Proposed Gore District Plan - McNabb Management Submission

Transportation Review

Prepared for	Gore District Council
Project Number	GODC-J002
Revision	A
Issue Date	6 November 2024
Prepared by	Logan Copland, Senior Transportation Planner
Reviewed by	Dave Smith, Technical Director - Transportation Planning

Figure 1.2 MML submission zoning

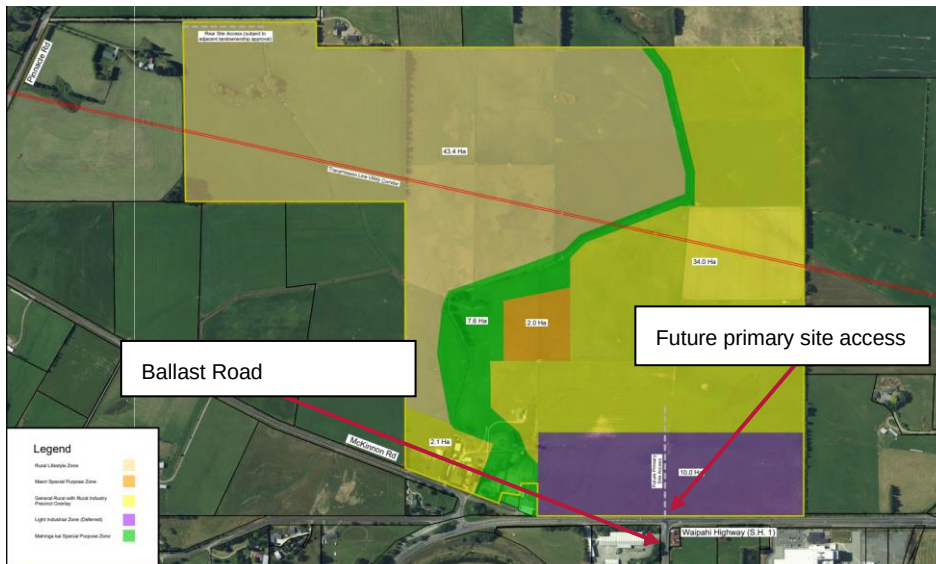
In the first instance, we note that the submission plan shows a new intersection from SH1, directly opposite Ballast Road which currently serves the Mataura Valley Milk Factory. We consider that an intersection in this location cannot be supported from a transport perspective because:

- The sight distance to the east is short of the minimums required in Austroads due to a crest in SH1, and
- Introducing a fourth leg to the intersection would create an additional conflict point where there is already expected to be a notable amount of turning activity and by heavy vehicles.

We consider that a new leg in this location would need to be accompanied by a speed limit reduction (maximum of 80k/h) and installation of a new roundabout. We have therefore focussed our assessment assuming that access to the Site is obtained from McKinnon Road instead as proposed in Mr Bartlett's evidence.

- Access to the wider transport from the rezoning Site be via McKinnon Road and not via Ballast Road / SH1 directly.
- The SH1 / McKinnon intersection should be upgraded to include a channelised left turn lane and confirm the existing right turn lane is in accordance with CHR requirements as opposed to CHR(s) prior to any development on the 10 Ha site.

Figure 3.2 Route between the Site and Gore (via Talbot Street/Wentworth Street/SH1). (Source: Google Maps).

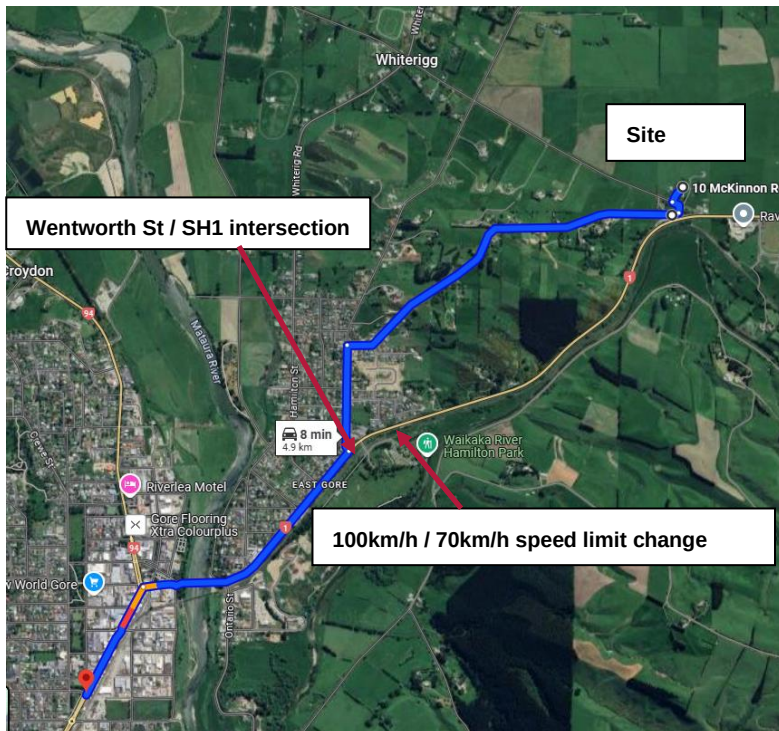
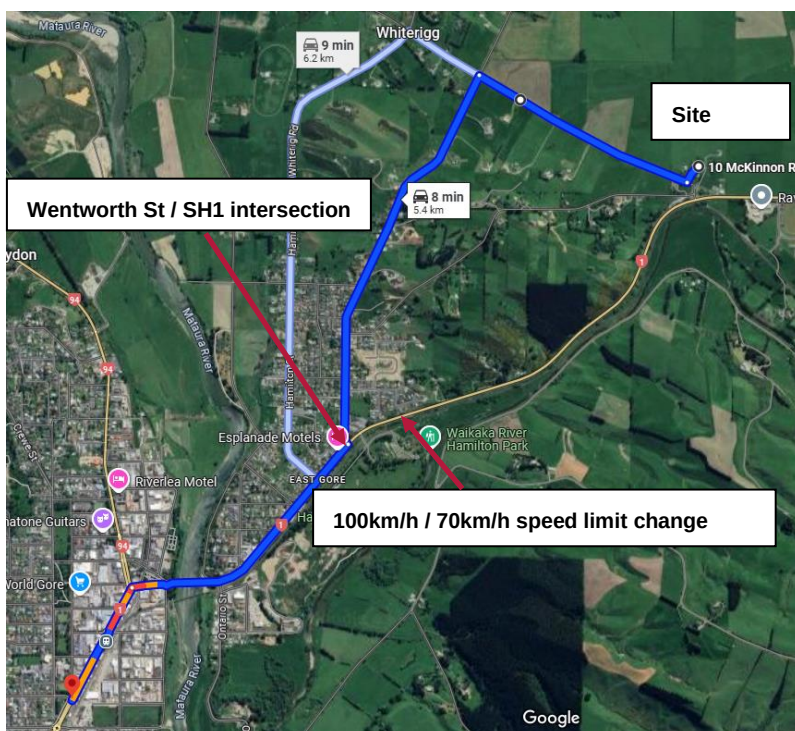
There has been no assessment of the use of alternative routes between the site and Gore, namely via Talbot Street and Wentworth Street (refer Figure 3.2 & Figure 3.3.)

If drivers want to avoid turning onto SH1 from McKinnon Road it is plausible they may use Talbot Street or Wentworth Street. As noted earlier Talbot Street is relatively constrained in width and alignment and is not conducive to high traffic flows. The ADT of Talbot Street indicates that it is operating as a Collector Road per the Gore Subdivision and Development Bylaw but it is not constructed to that standard.

If drivers want to avoid Talbot Street due to these constraints and want to avoid turning onto SH1 at McKinnon Road due to the high-speed environment, an alternative route would be to use McKinnon Road and then turn left onto Wentworth Street. Although Talbot Street and Wentworth Street are slightly longer and less direct than the SH1 route, they could be attractive alternative routes into Gore if delays and queues at the McKinnon Road / SH1 intersection increase. We note that the traffic impacts of additional use of Talbot Street and Wentworth Street have not been assessed by Mr Bartlett but recommend this be given further consideration.

- NZTA as the road controlling authority for SH1 should be consulted to ensure their maintenance programme would eliminate the potential for vegetation to obscure the view of vehicles turning into / out of McKinnon Road.
- Additional assessment is required to understand the potential effects on Wentworth Road and Talbot Road.
- Noting that the development is within cycling distance of Gore, any opportunities to provide safer environment for cycling to the site (such as reducing vehicle speeds) would support mode choice. However, we consider that the provision of dedicated cycle facilities between the site and Gore is not required to support the development.

Figure 4.1 CHL with offset as per Austroads

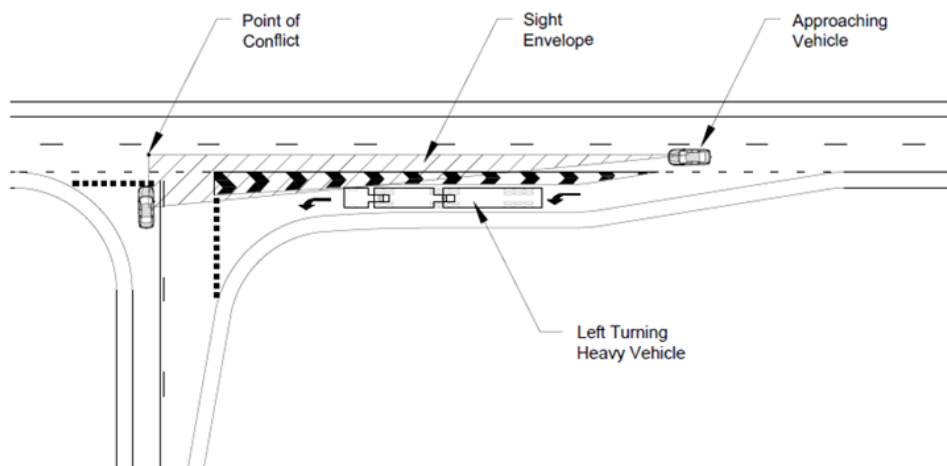
In terms of the upgrades specifically we agree with the Mr Bartlett's SH1/McKinnon Road warrants assessment in that a channelised left turn lane is required to support the development, and consider that this will need to occur prior to any development of the 10Ha Light Industrial site. We emphasise that the upgrade will need to include an offset from the through lane to preserve visibility, see Austroads Guide to Road Design Part 4A.

We further recommend that the CHL treatment be designed in accordance with the Austroads Guide to Road Design part 4A figure 8.6 which is shown here in Figure 4.1.

Figure 4.4 Turning conflict (red and blue arrows) and rezoning land access (yellow star and arrow)

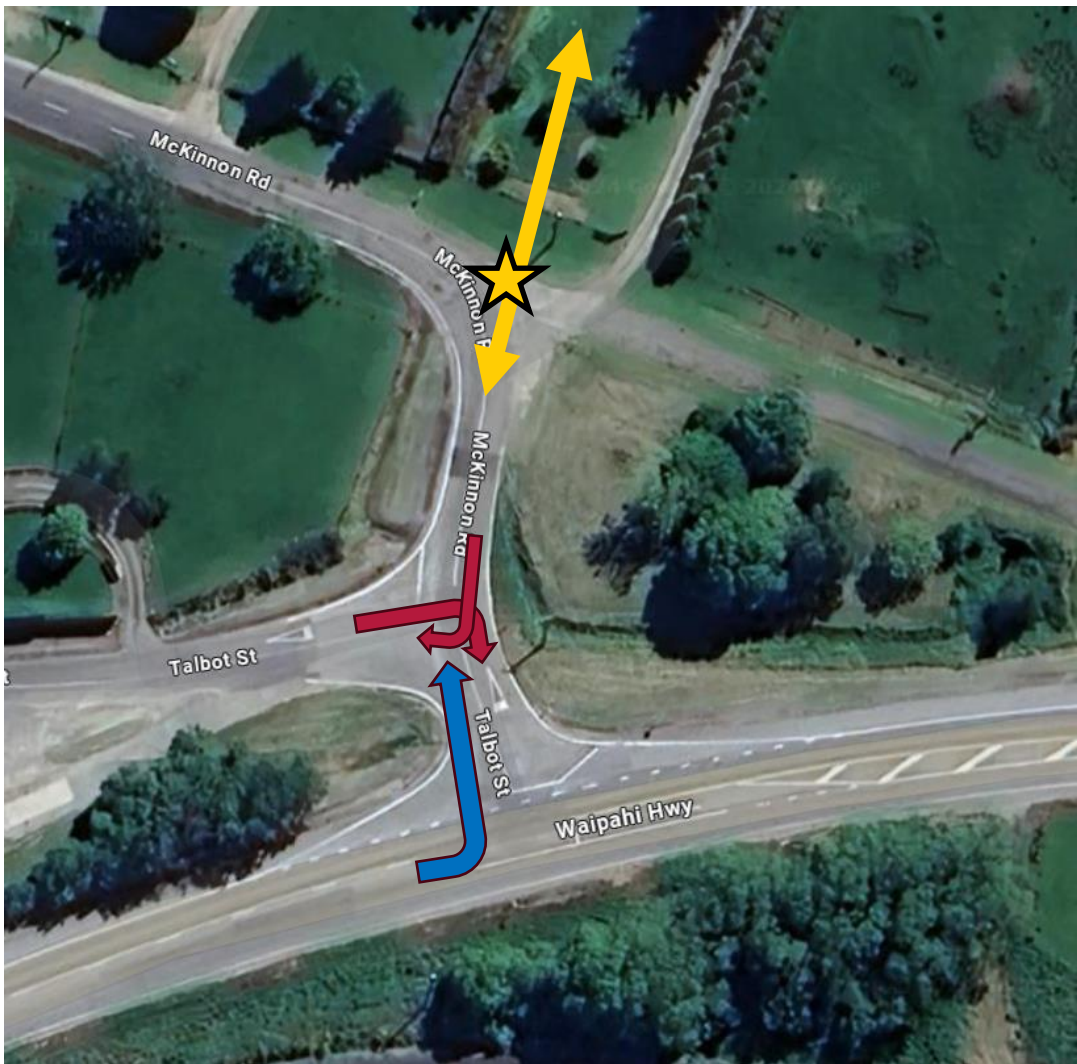
The current intersection configuration of McKinnon Road / Talbot Street and the site access is problematic due to the minimal spacing between the intersections. This is of particular concern for vehicles turning left into McKinnon Road from SH1 (blue arrow below) as there is limited space for a driver to react to a vehicle that is turning right into or out of Talbot Street (red arrows below) - refer to Figure 4.4.

We consider the risk of this could be mitigated to some extent as part of the intersection design (such as ensuring the radii of any new left turn bay is sufficiently small to reduce the speed of left turning vehicles), but we recommend that the submitter provides an assessment of this issue.

Moreover, given the relatively low traffic flows currently on McKinnon Road it is likely that should the site be rezoned, the dominant flow with development will be into and out of the new site access. We therefore recommend that should a new intersection be formed at the elbow in McKinnon Road (at the location of the yellow star in Figure 4.4), priority should be given to traffic entering and exiting the development as shown by the yellow arrow in Figure 4.4, with traffic from the existing northwestern approach on McKinnon Road being give way or stop controlled. This would also provide for better sight distances at the new intersection, and at the MacKinnon / Talbot intersection.

- Should further development be undertaken on the site beyond the 10 Ha in the original submission, further upgrades may be required.
- The left turn lane from SH1 into McKinnon Road should be designed to substantially reduce the speed of turning vehicles, minimising the potential for conflict with vehicles turning into or out of Talbot Street.

- A potential new intersection at the current elbow in McKinnon Road should give priority to traffic entering and exiting the rezoning site. This improves sight distances and would in our view provide the safest outcome.

Figure 4.6 Sightline to the west

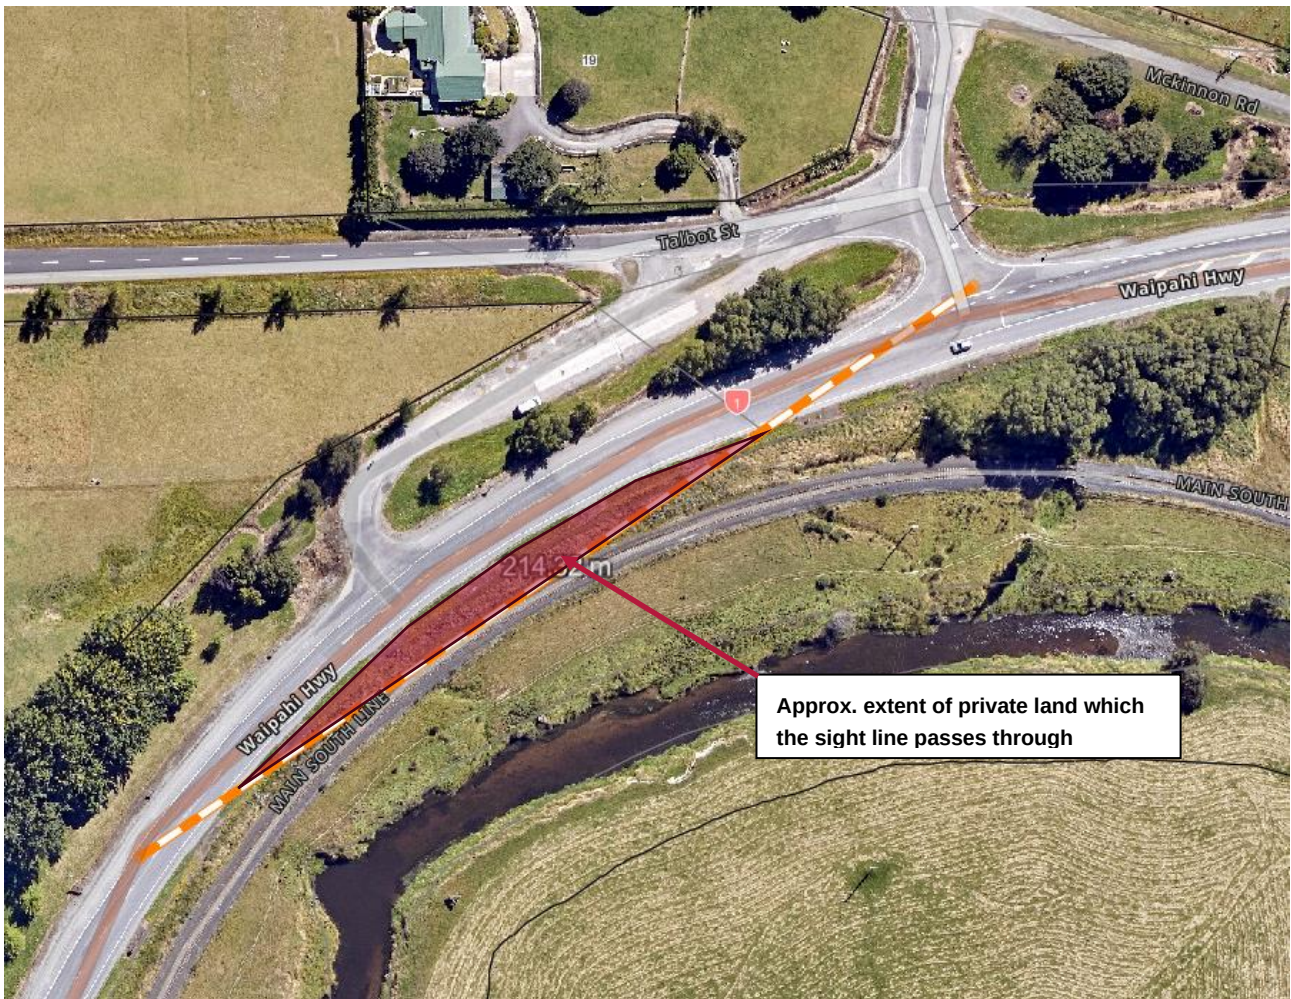
The Transport Assessment did not review the sight distances at the McKinnon Road / SH1 intersection. Based on a speed environment of 90km/h on SH1 and assuming a reaction time of 2.0s a SISD of 214m is required. This is achieved to the east (refer Figure 4.5) but to the west the sight line passes outside of the road corridor but remains on the inside of the Main South Rail line (refer Figure 4.6). Therefore, the required sight distance is available but due to the horizontal curve it passes through private land. In some cases this would be considered a risk given that land is not in the control of the Road Controlling Authority and could therefore be built out in the future. In this case the risk is low because of the Main South Line.

We also note from the crash analysis that there have been no crashes recorded that could be attributed to a shortfall in sight distance, but given the increase in traffic flows through the intersection we consider it important to ensure that the Road Controlling Authority (NZTA) reviews how the sight line could be protected in perpetuity (such as by monitoring growth of and cutting back any vegetation as part of their maintenance programme).
